ADDENDUM NO. 1

CCS West Bell County Service Complex

MRB GROUP PROJECT No. 2919.24002.000

SECTION 00 91 13 – ADDENDA 1

1 REFLECTED CEILING PLAN
1/8" = 1'-0"

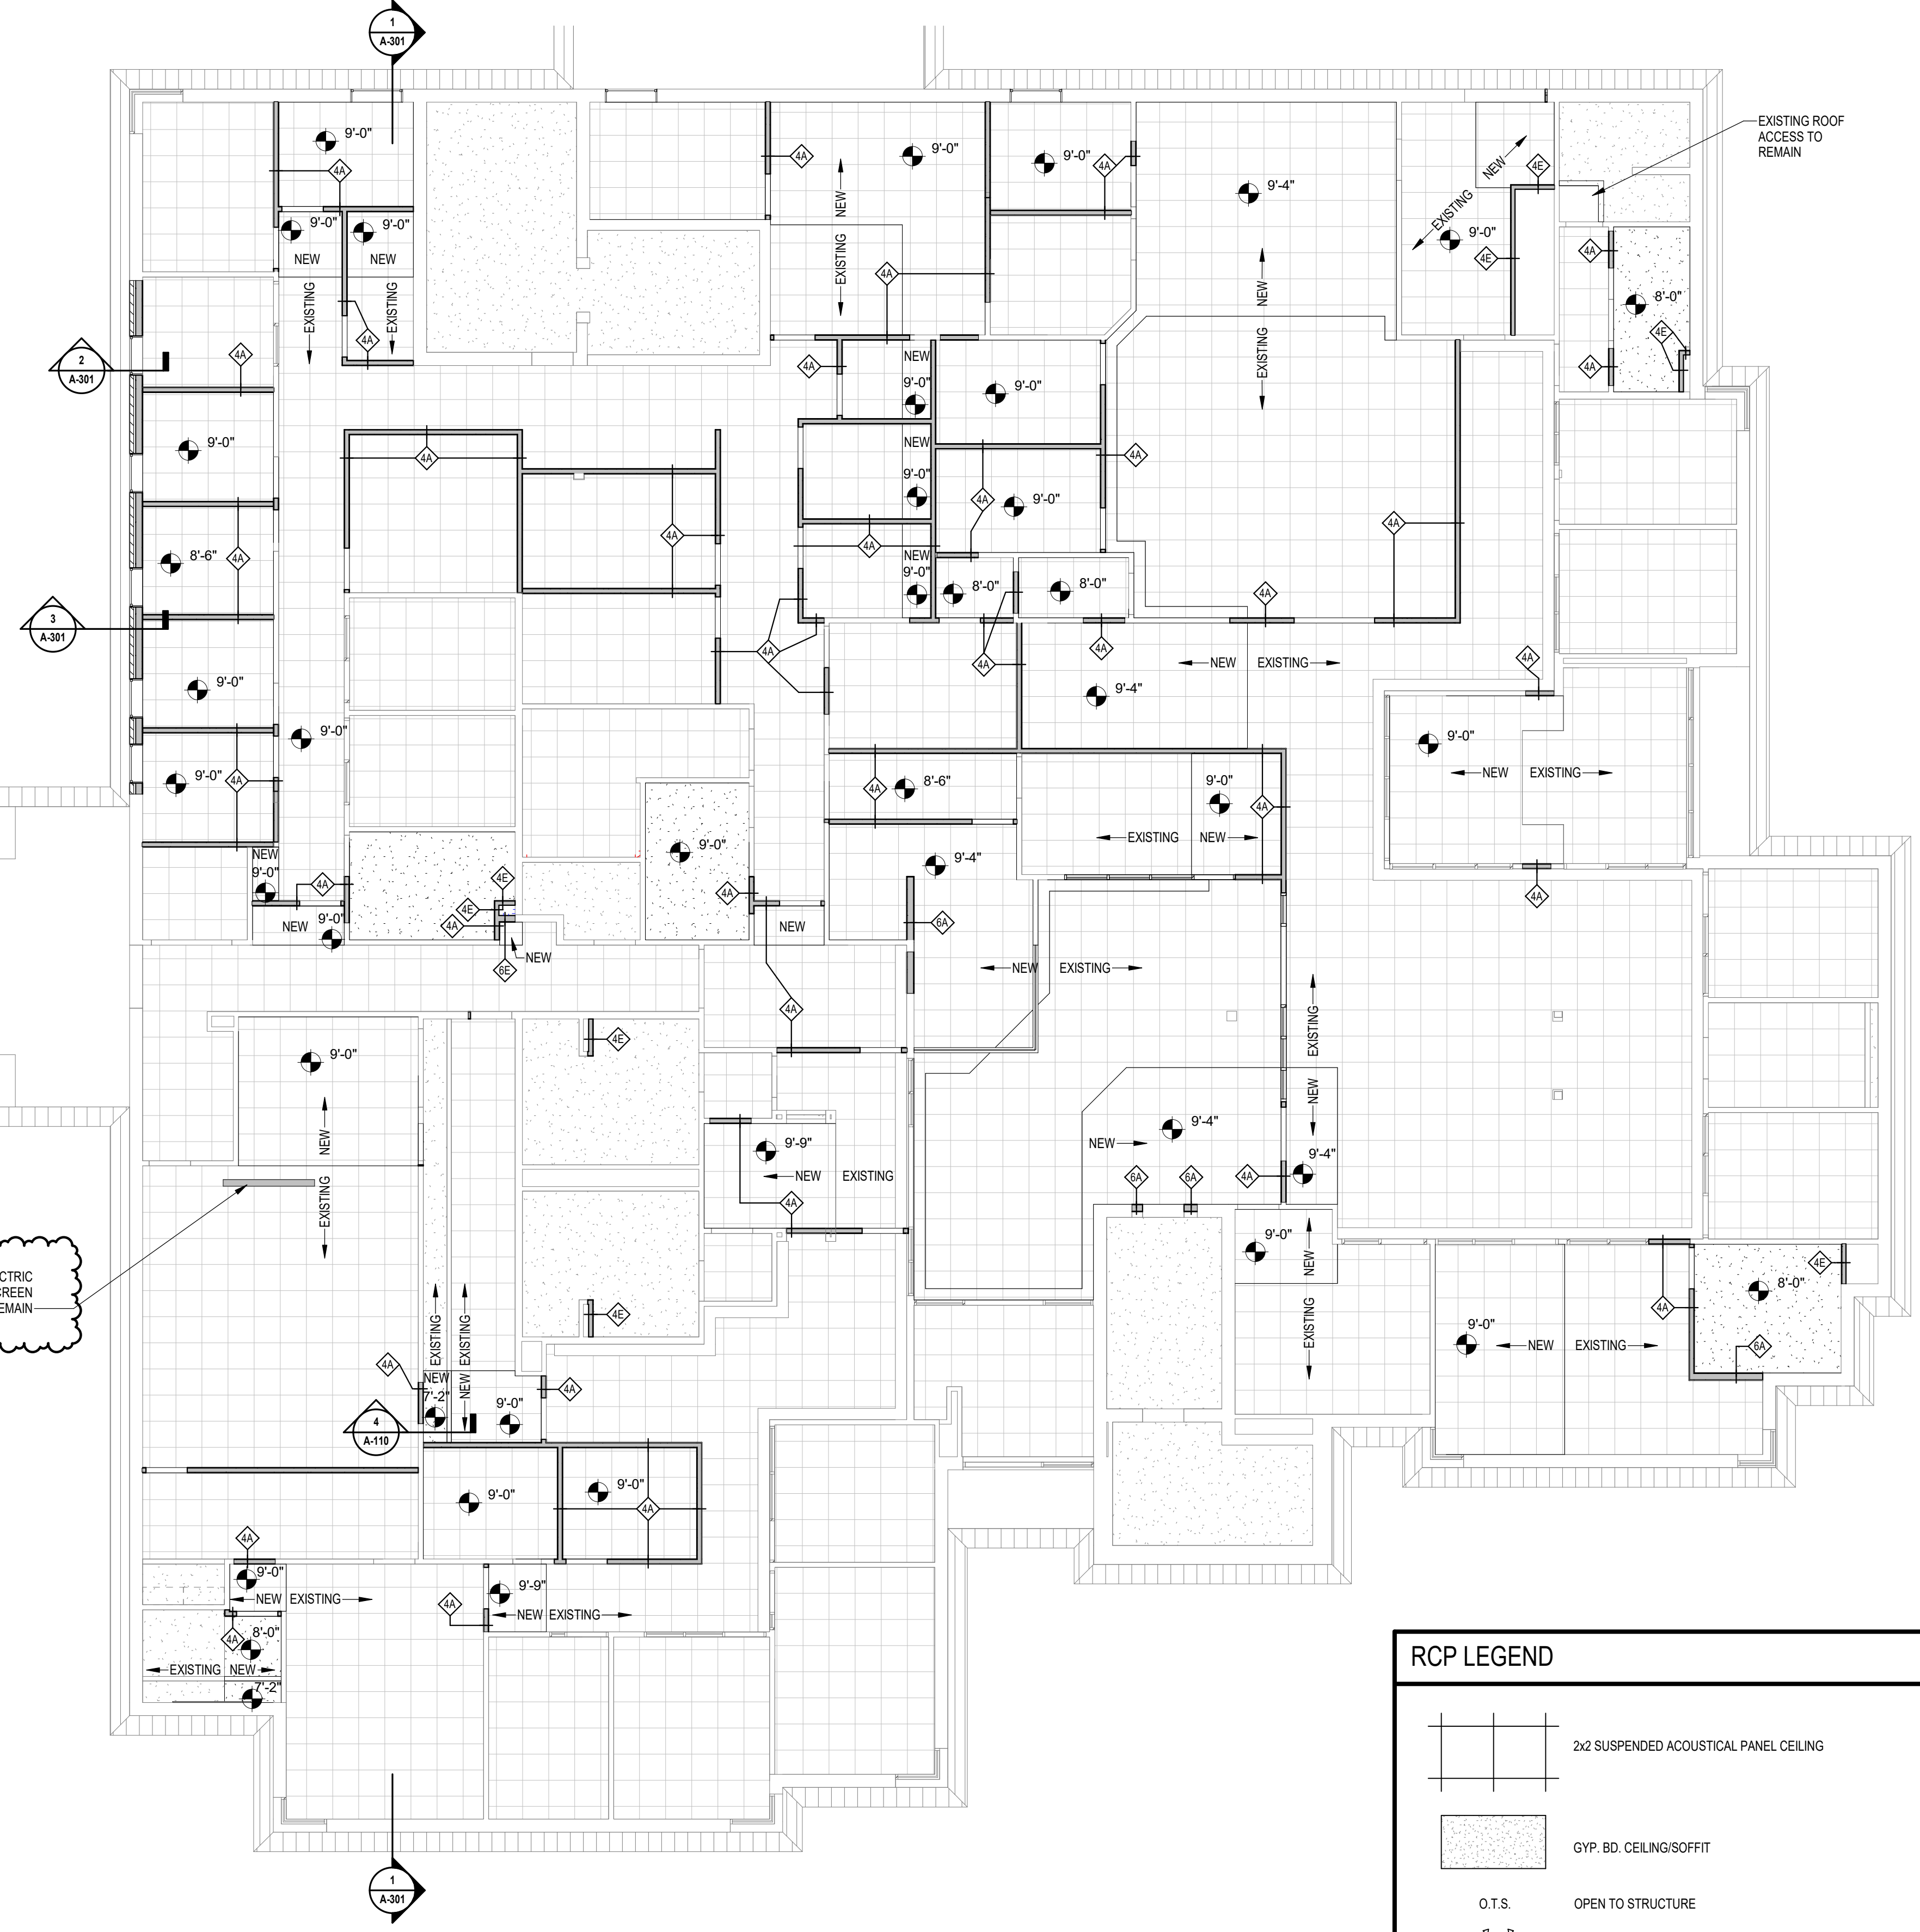
Drawing Number	View, Detail, Section	Description of Action Required
A602	1	ADDED FROSTED AND TEMPERED FILM
A701		ADDED INTERIOR SIGNAGE NOTE
A110	1	ADDED NOTE 'ELECTRIC PRESENTATION SCREEN TO REMAIN'

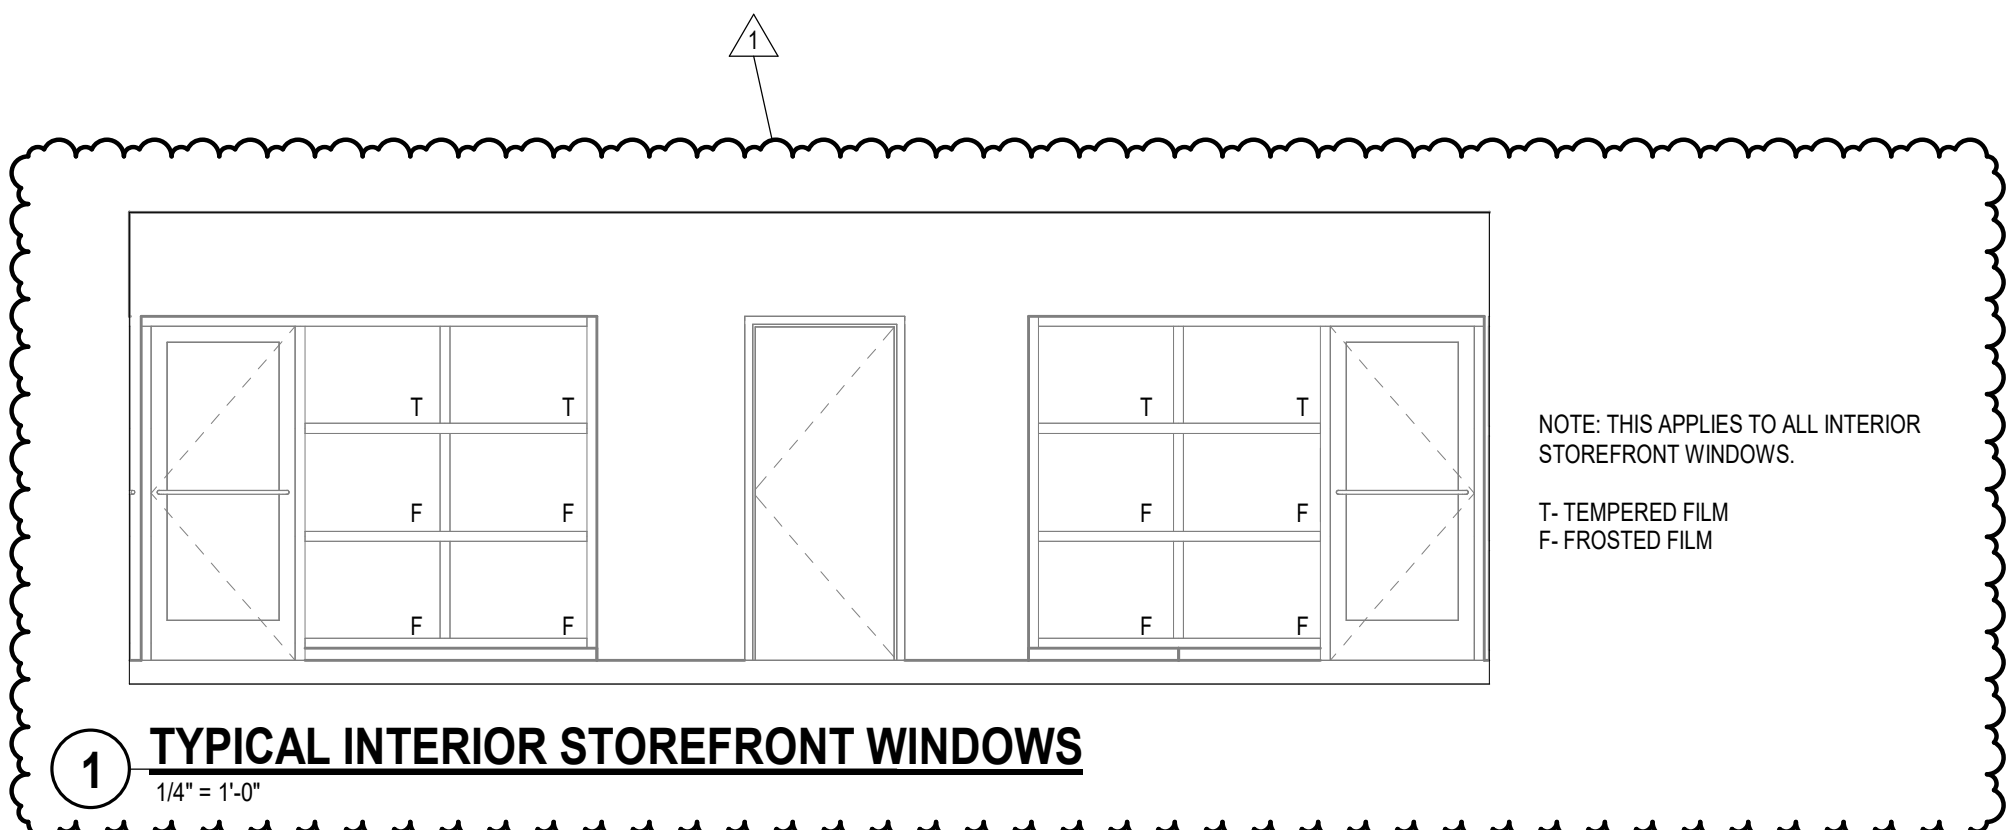
1. G.C. TO VERIFY ALL ROUGH OPENING DIMENSIONS.
2. ALL EXTERIOR STOREFRONT ALUMINUM FRAMING TO HAVE 1" LOW-E INSULATED GLAZING, SEE GLAZING TYPES ABOVE.
3. ALL EXTERIOR GLAZING TO BE "G1" UNLESS OTHERWISE NOTED.
4. PROVED TEMPERED GLAZING IN ALL WINDOWS WITHIN 24" ADJACENT TO ANY DOOR EDGE (WHEN CLOSED) & WITHIN 16" OF THE FINISHED FLOOR.
5. PROVIDE BACKER ROD & SEALANT AT ALUMINUM FRAMING PERIMETER INTERIOR & EXTERIOR. COLOR OF SEALANT TO MATCH ALUMINUM FRAMING FINISH COLOR.
6. SEE DETAIL THIS SHEET FOR TYPICAL WINDOW FLASHING. REFER TO MFR. FOR ADDITIONAL INFORMATION.
7. G.C. TO VERIFY EXTERIOR GLAZING COLOR AND SHADING MATCHES EXISTING.
8. ALL EXISTING INTERIOR STOREFRONT WINDOWS TO RECEIVE A TEMPERED GLASS FILM ON BOTH SIDES AT ALL TOP SECTIONS. ALL BOTTOM TWO GLASS PANELS TO RECEIVE A FROSTED FILM ON EACH SIDE. SEE DETAIL THIS SHEET FOR TYPICAL FILM LOCATIONS.

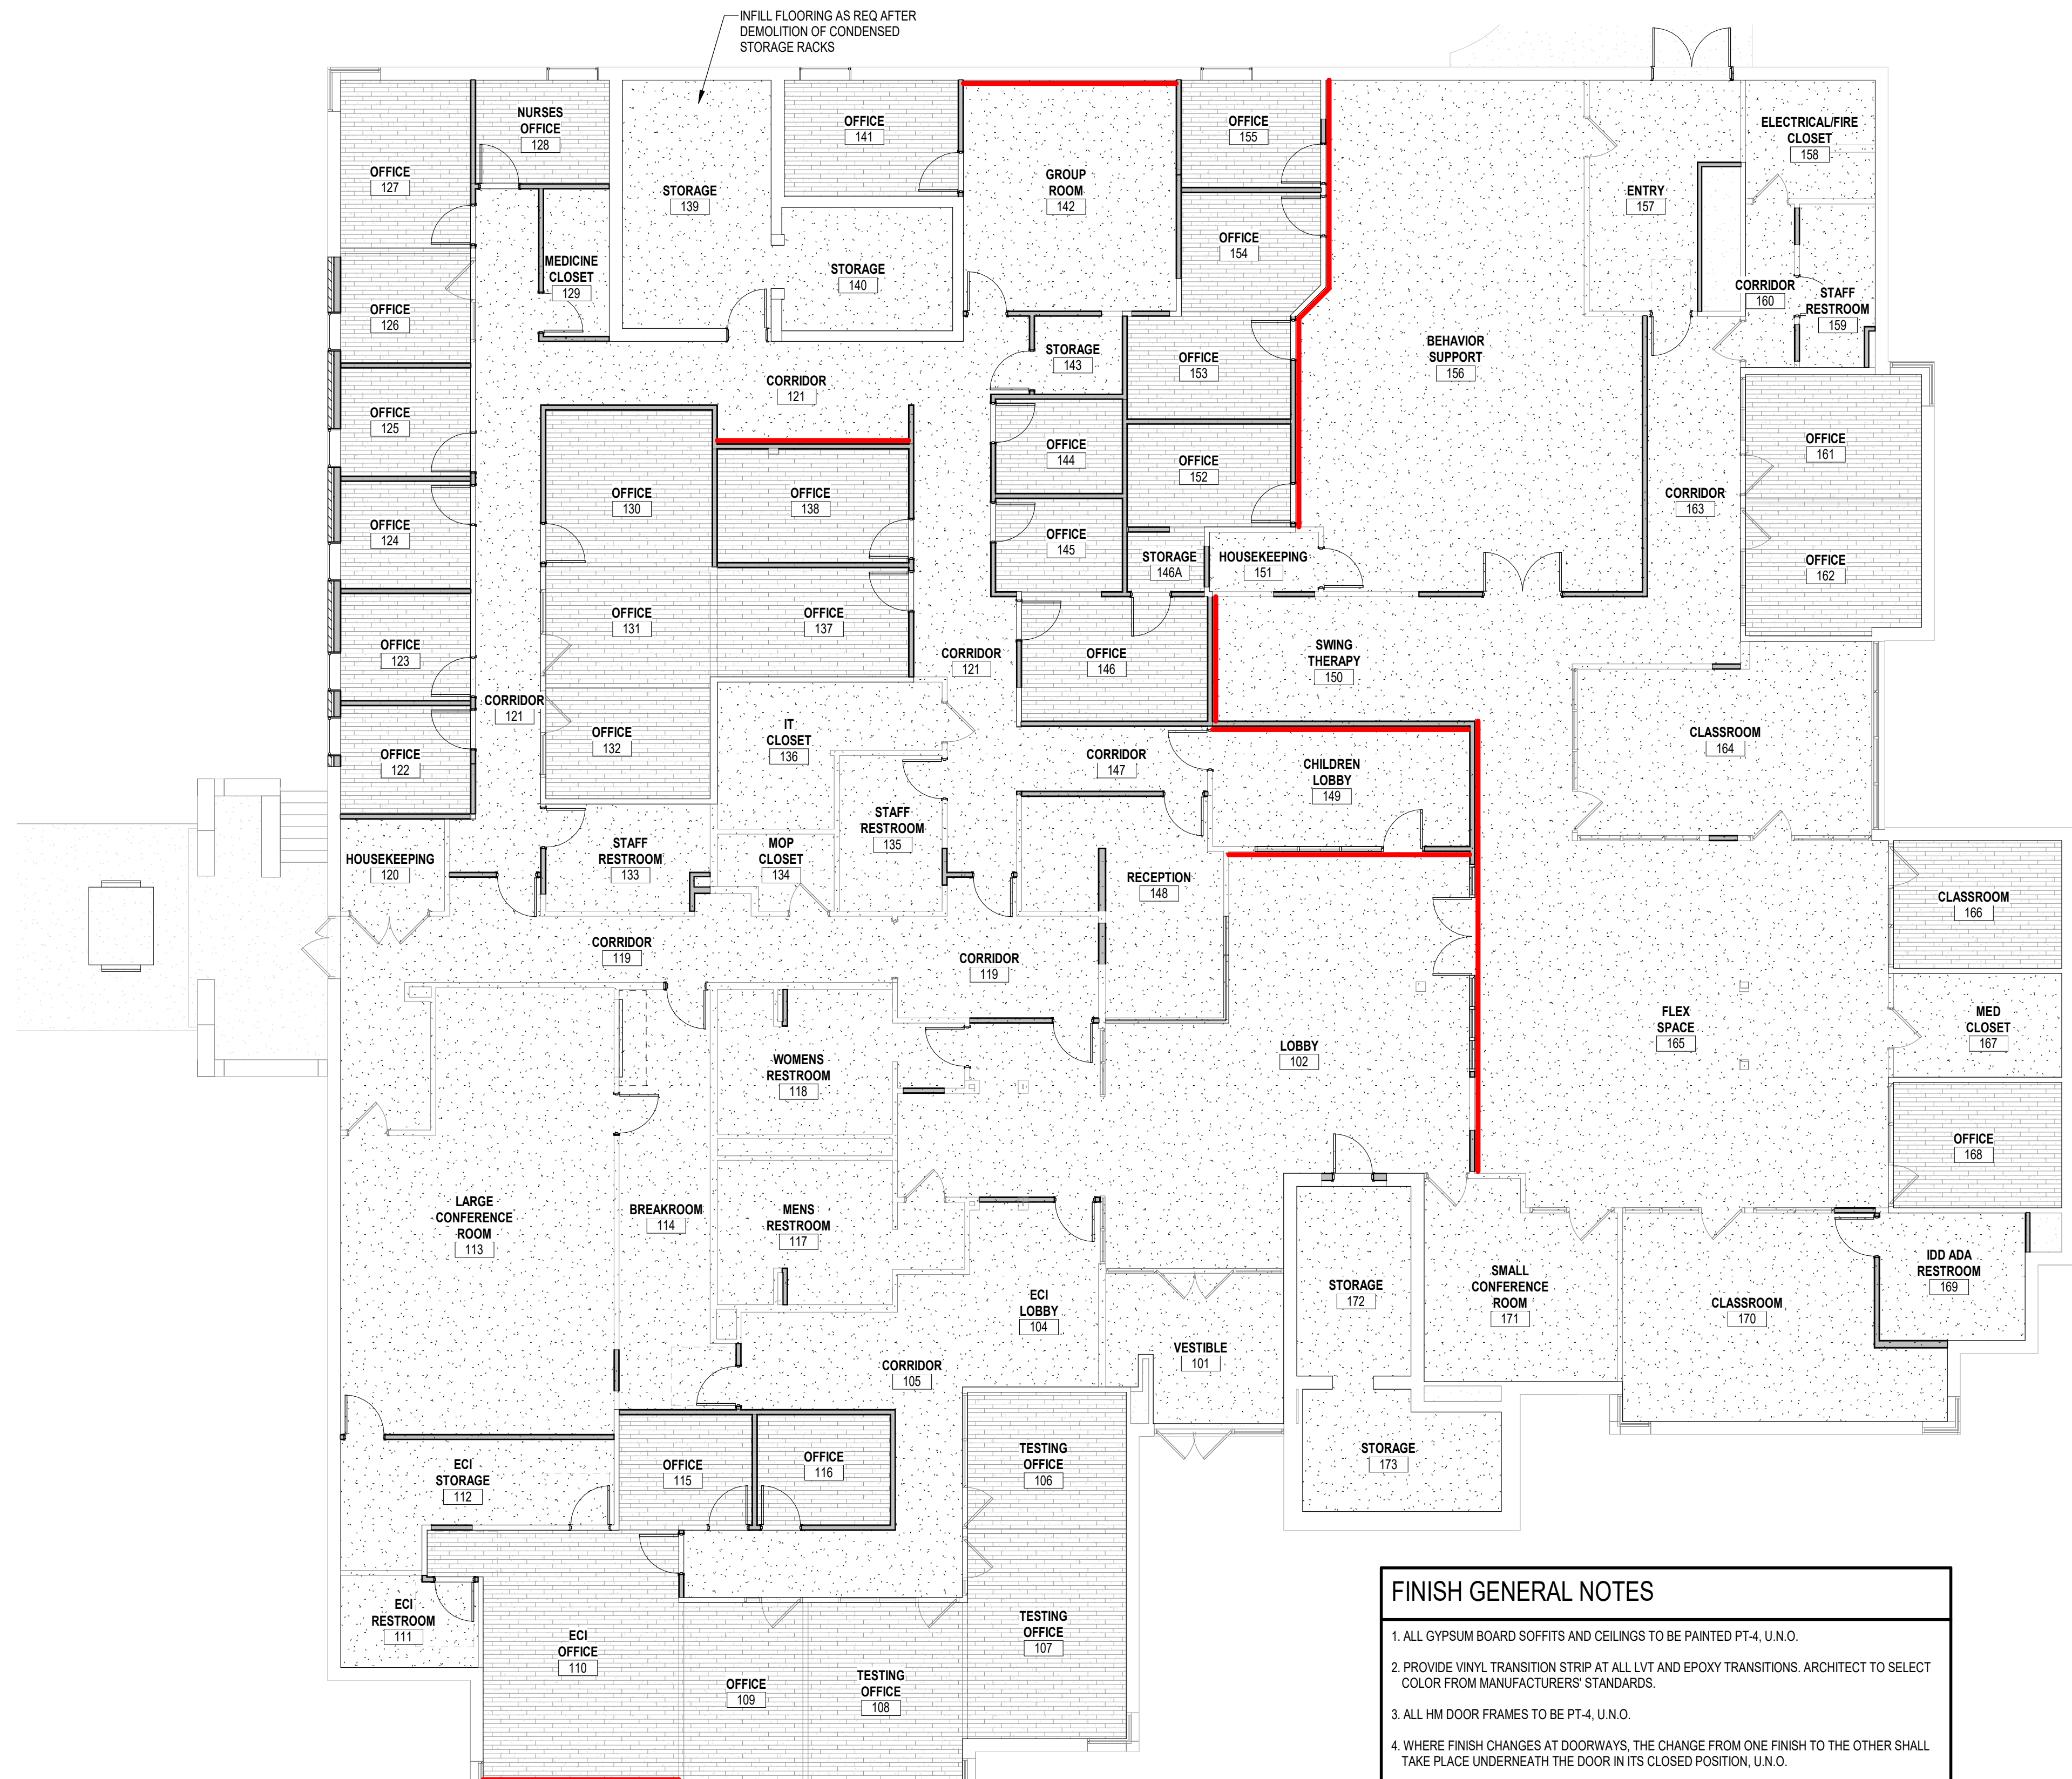
6. Is this project tax exempt?
Yes
7. Will there be any interior room signs?
Yes. See revised sheet A701.
8. What is the plan for the furniture?
All movable furniture will be moved by CCS prior to construction starting. Cubicles and collapsible storage racks in the vault are to be taken care of by CCS unless changed in future addendum. Please include removal of the 3 fire rated filing cabinets and storage lock boxes in vault at the front entrance.
